T.I. no.: 2017 - 10 Updated: -	Topic: SCA P Best Foam™ switching valve
---	--

Date: 19/7/2017
Affected machines: SCA P Best Foam™
From serial number: -
As of date: 1/4/2017

Installation of switching valve up to 1/3/2017

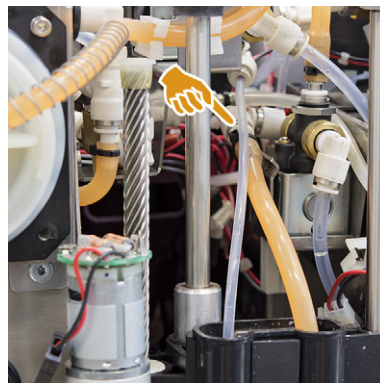
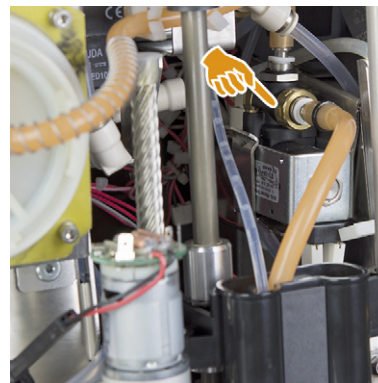
The switching valve including the holder was rotated by 180°. The cable connections from the cable harness to the switching valve are therefore too short. The cable harness has been adjusted accordingly.

Installation of switching valve from 1/4/2017

The new holder as well as an extension cable are required for replacing the switching valve.

For machines produced before 1/3/2017, the spare parts listed below must be ordered to replace the switching valve.

Spare parts for switching valve

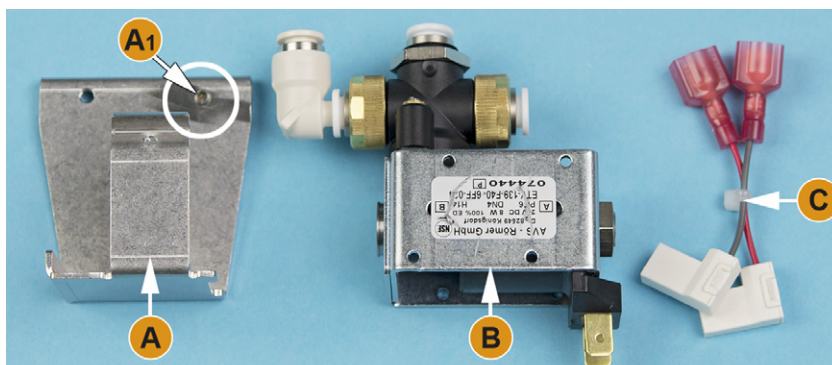
The following spare parts must be ordered for the replacement of the switching valve:

- [A] 074412 Switching valve holder
- [A1] 1008022 Threaded pin screw M4x6
- [B] 074440 Switching valve
- [C] 072052 Extension cable
